Case No. 2020-00208
Northern Bobwhite Solar LLC
Responses to Harvey Economics' Second Request for Information

I. Construction phase activities

II. Site development plan

Northern Bobwhite - Preliminary Engineering and Construction Timeline

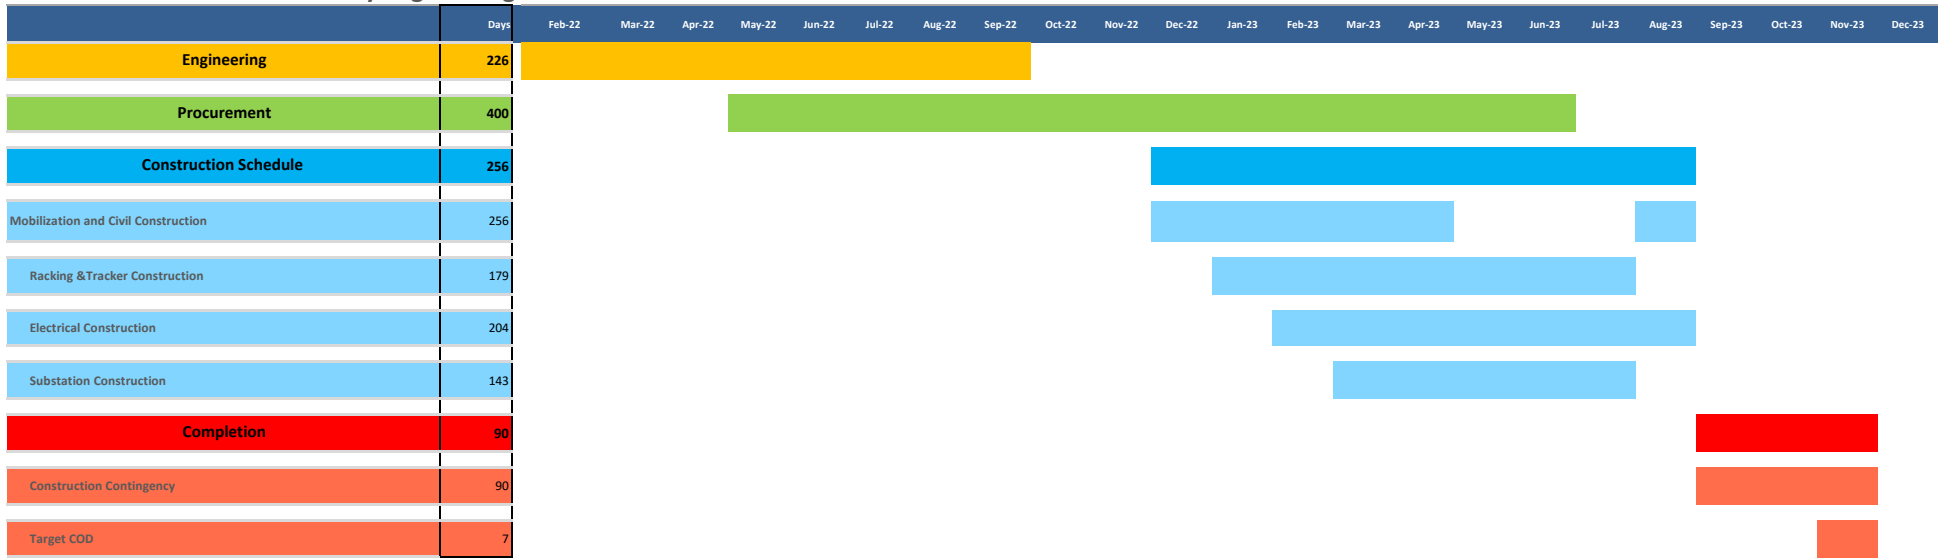
- 1. Please provide any additional information about the schedule of work to be performed throughout construction activities. Information regarding the sequencing of work to be done throughout the site would be helpful.**

Despite these unknowns, Bobwhite has prepared a preliminary engineering, procurement and construction schedule based on its affiliates’ experience with other similarly sized solar projects. The preliminary weekly schedule is included as Exhibit A and the preliminary monthly schedule is included as Exhibit B. Bobwhite currently expects site construction activities to take approximately 37 weeks of active work, with an additional 13 weeks of contingency to account for weather delays and other unknown factors.

Revised Site Overview Map

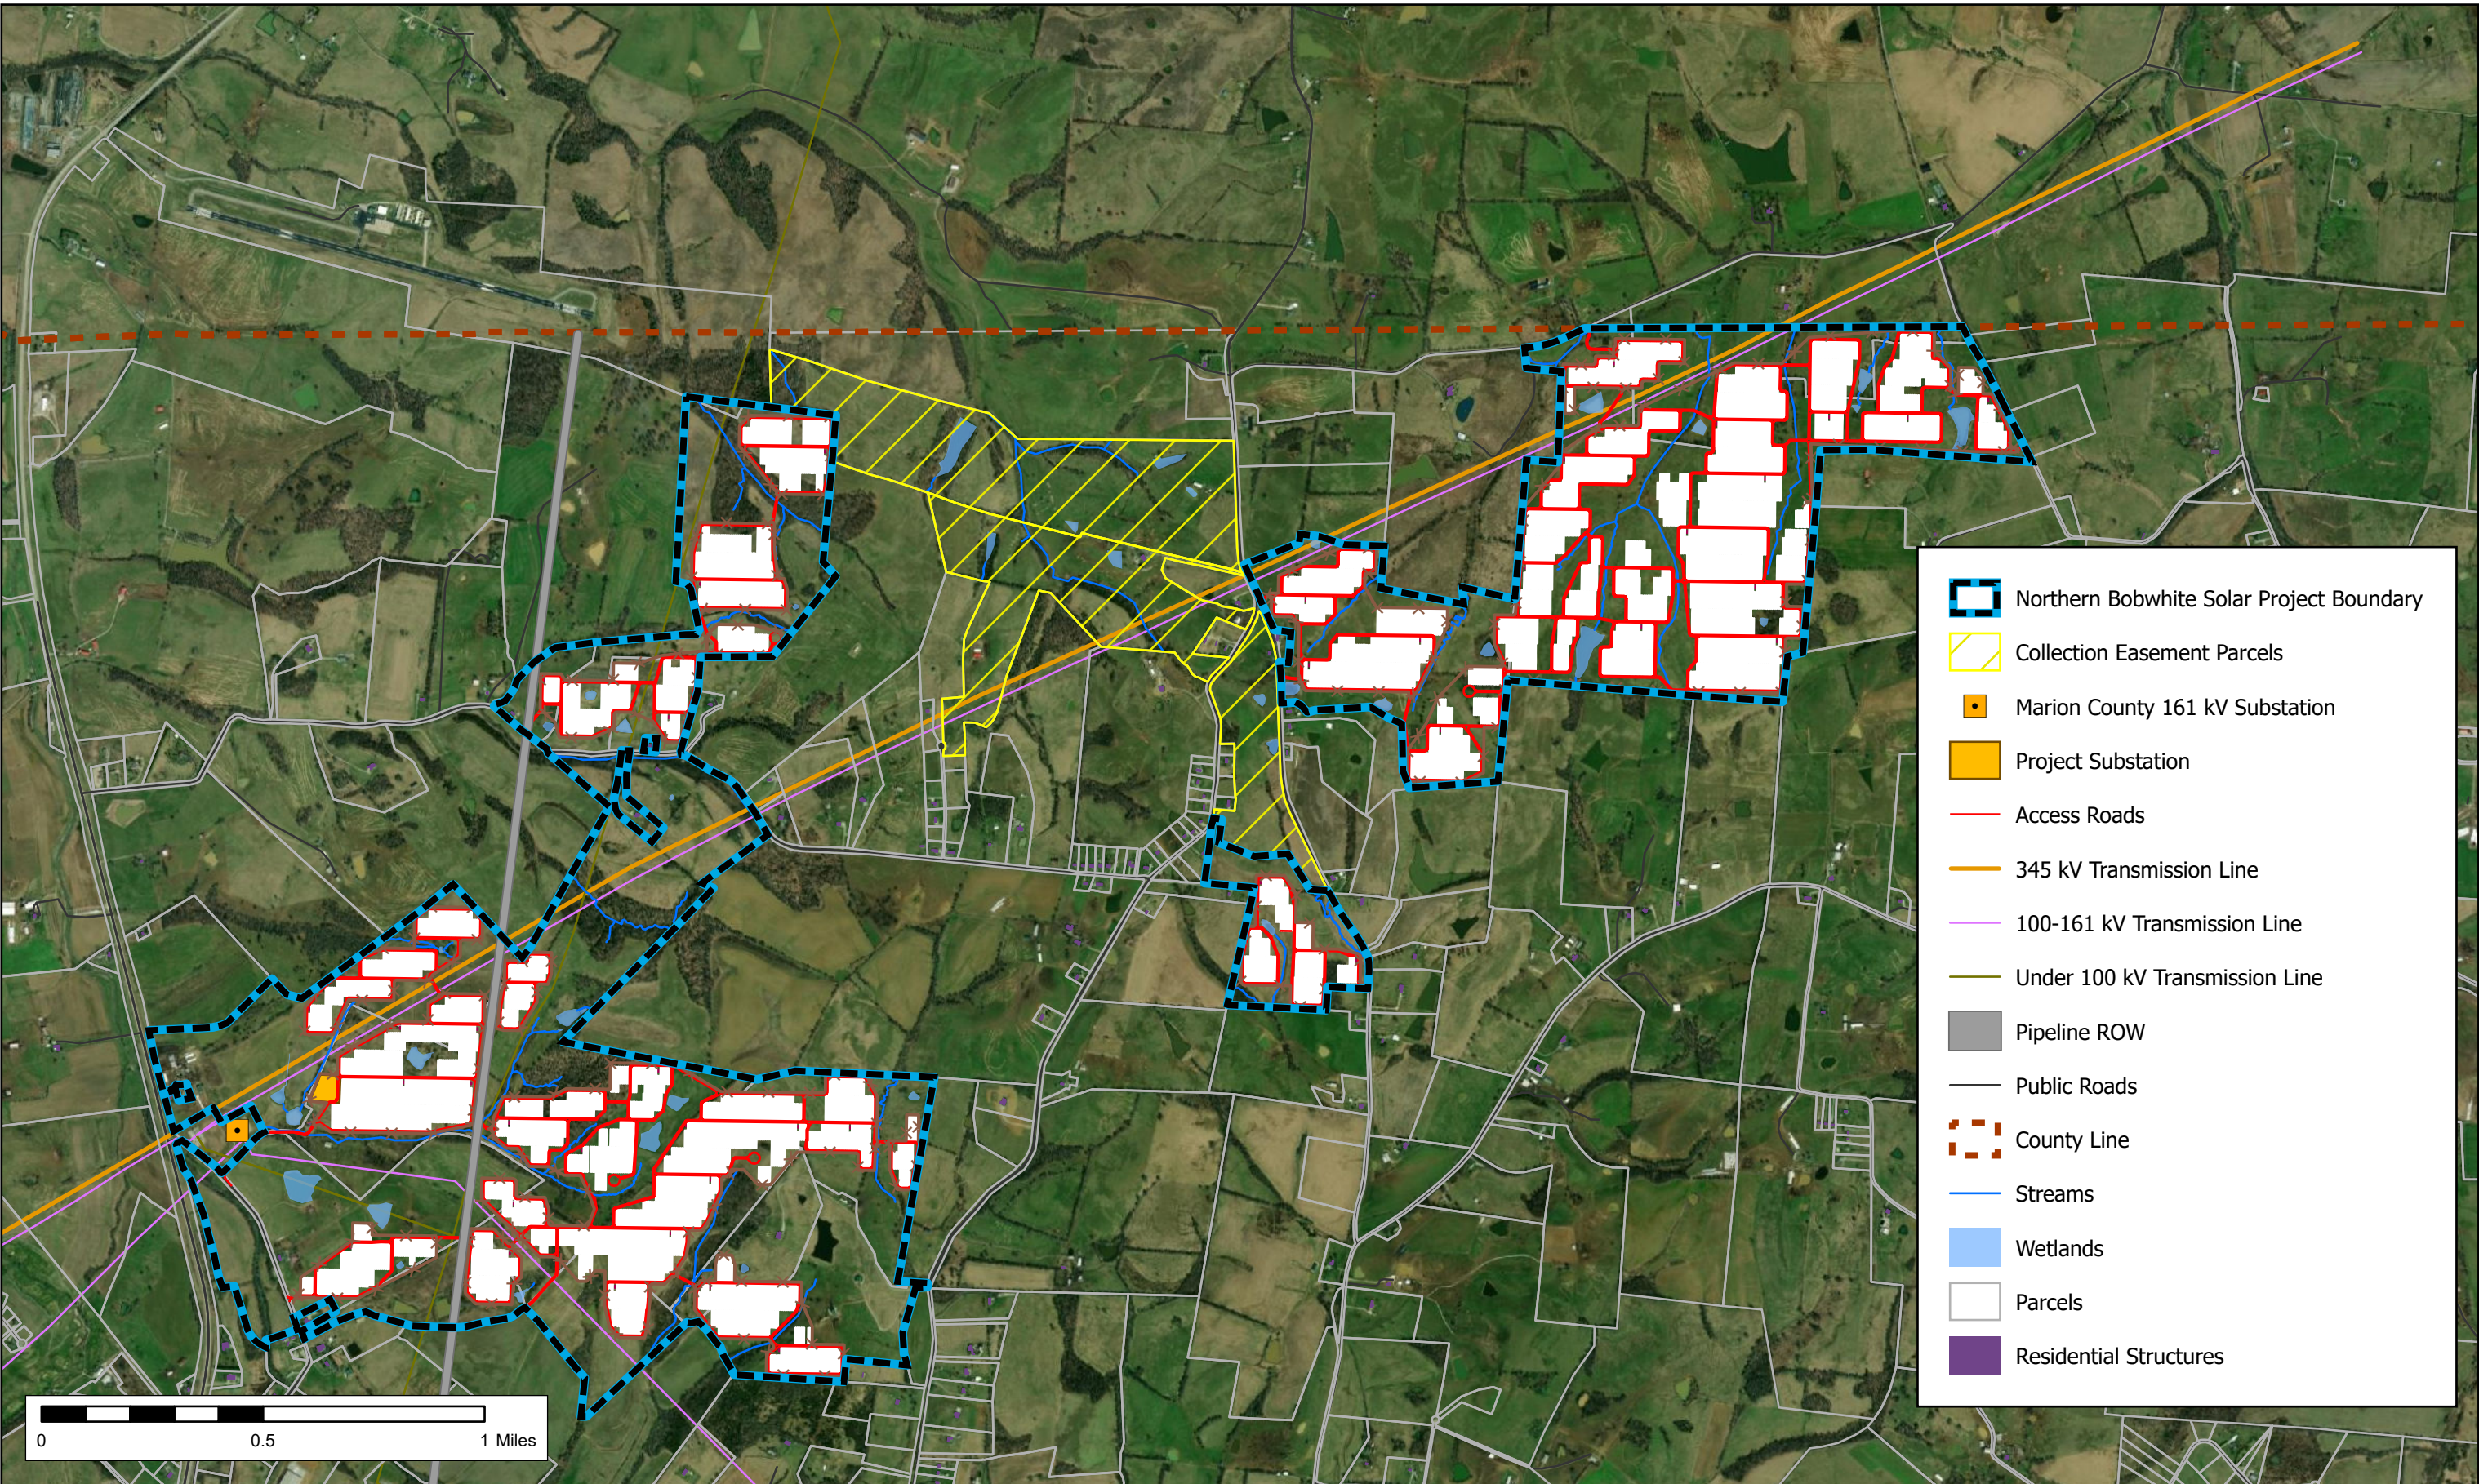
- A. We would like to include the Site Plan Overview map in our report. Please provide a revised site plan overview map (the main overview map that shows the entire Project boundary) that correctly locates the Marion County Substation outside the Project boundary and also removes the “Map Page 1-4” overlay.**

Response: *Please see Exhibit D, Revised Site Overview Map.*

The Project boundary encompasses portions or all of the parcel boundaries in Appendix B to the SAR. Some parcels, for example, tax parcel 064-001 referenced above, are only partially included in the project boundary. Since Bobwhite has not yet independently surveyed the site, we are unable to verify the legal descriptions accompanying the parcel deeds, nor are we able to submit a legal description specific to the project boundary. For the sake of clarity, Applicant has resubmitted the previous Exhibit L (Updated Land Control Map) as Exhibit E to show to easement parcels and more clearly identify the location of 064-001. The Exhibit D Revised Site Overview Map has also been updated.

Revised Updated Land Control Map

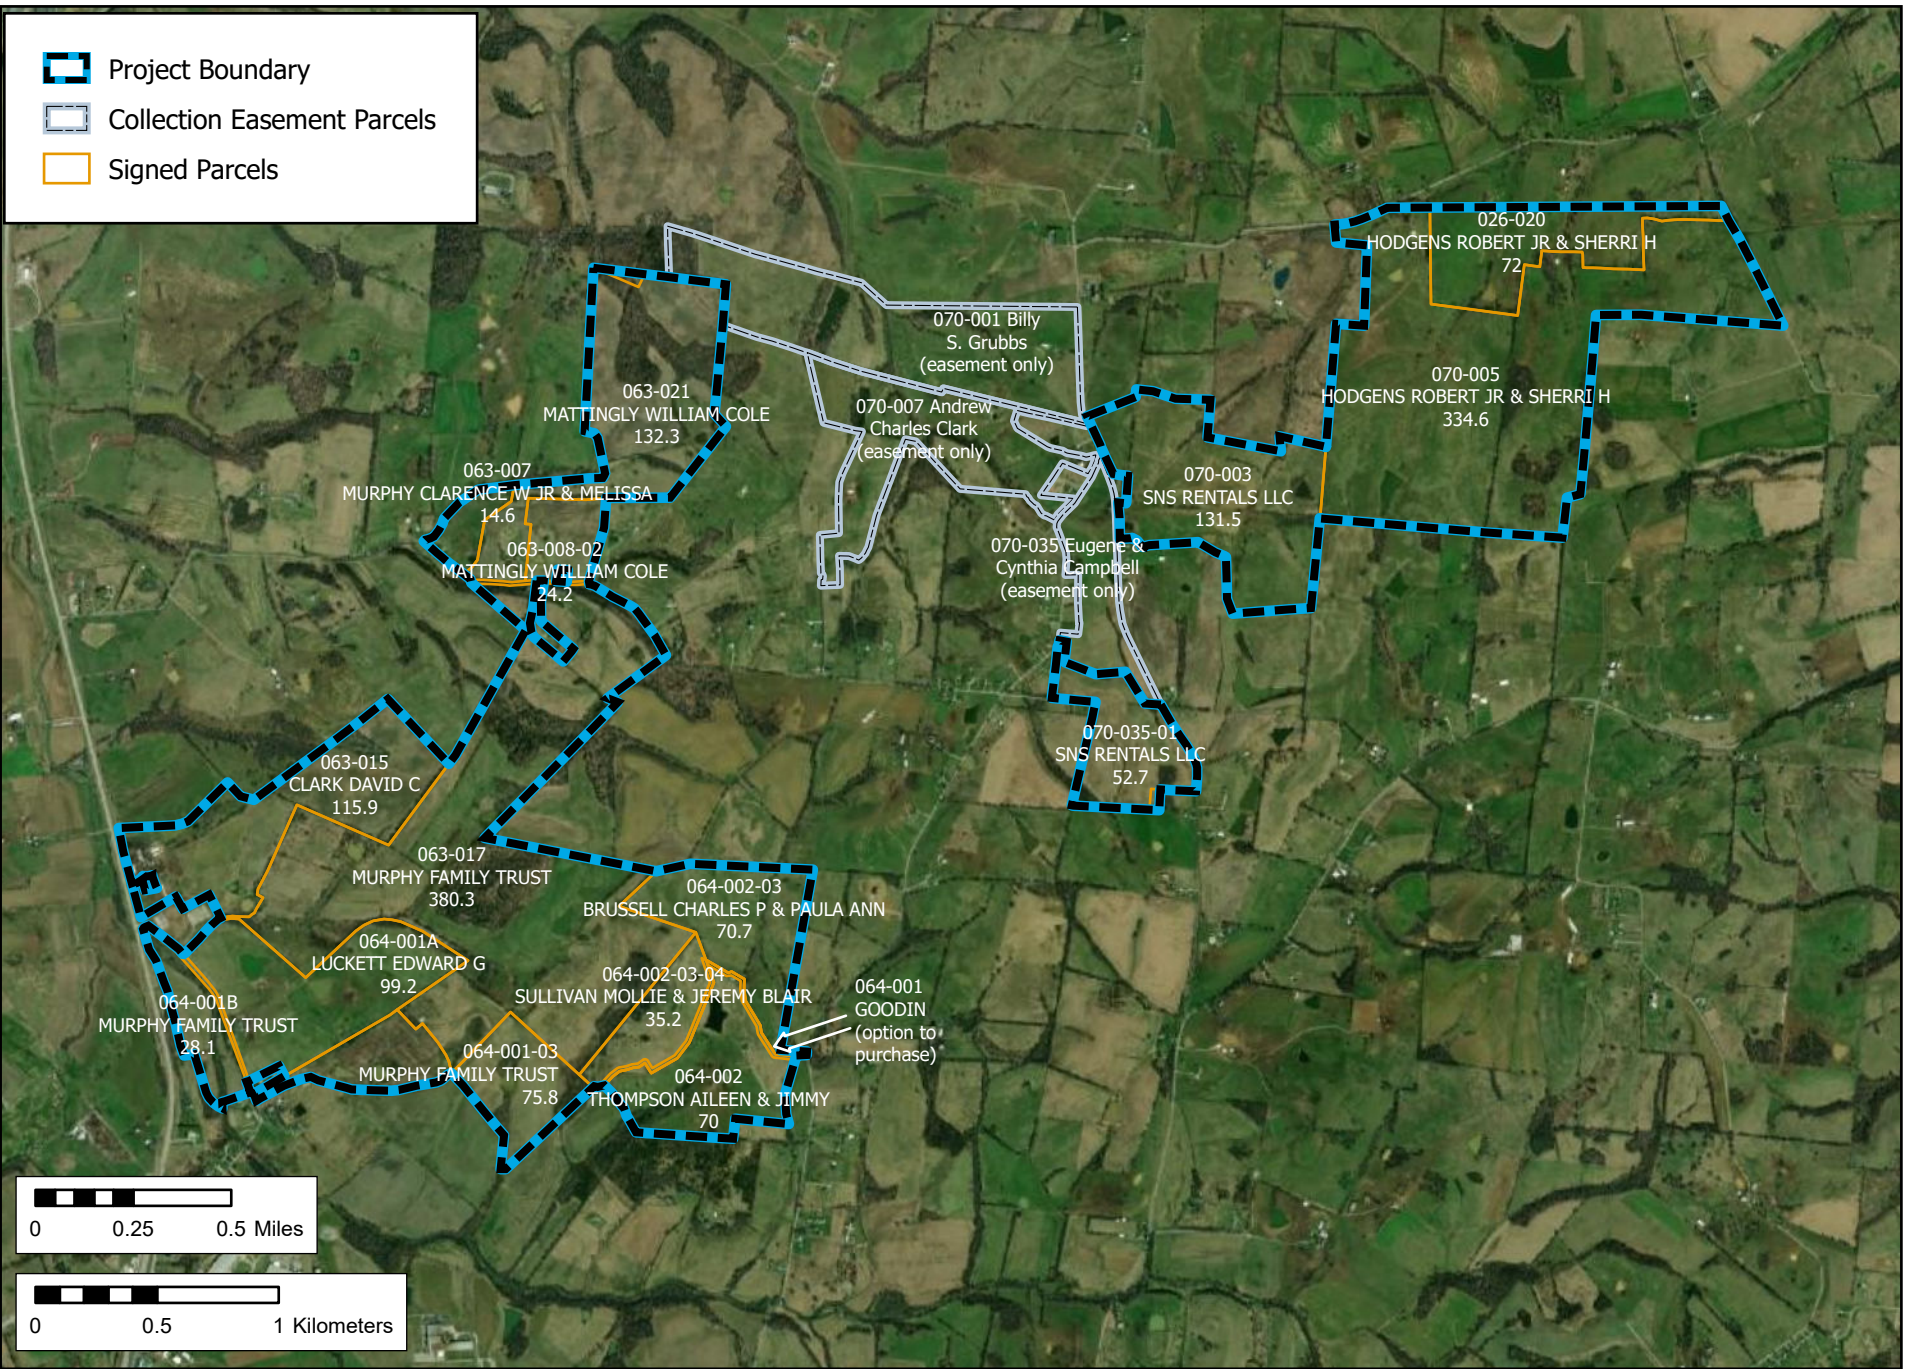
E. Please confirm that the information provided in Exhibit L of the response to RFI #1 (Updated Land Control Map) is consistent with the legal boundary description provided in Appendix B of Exhibit O of the Application.

The Map provided previously as Exhibit L depicts the boundary of the Project and is consistent with the legal boundary description previously provided in Appendix B of Exhibit O (the Site Assessment Report ("SAR")) with one revision: tax parcel 070-035 was mistakenly shown within the project boundary. This parcel has an underground collection easement but is not within the solar boundary. The map has been updated and submitted as Exhibit E. Several clarifying notes which may be helpful:

- *Legal descriptions are provided for two tax parcels (070-001 and 070-007) in Appendix B to the SAR that were not depicted in Exhibit L. The landowners for these two parcels have entered into easement agreements with Bobwhite and have been represented in other Exhibits as The Easement Parcels. These easement parcels have been identified in the updated Exhibit E, which should replace Exhibit L to the response to RFI #1.*
- *A legal description for tax parcel 064-001 is provided in Appendix B to the SAR but was not depicted in Exhibit L, although it is within the Project boundary. The portion of the parcel within the Project is an approximately 50' wide strip of land that was too small to visualize. The portion of tax parcel 064-001 within the Project boundary has been identified in Exhibit E.*
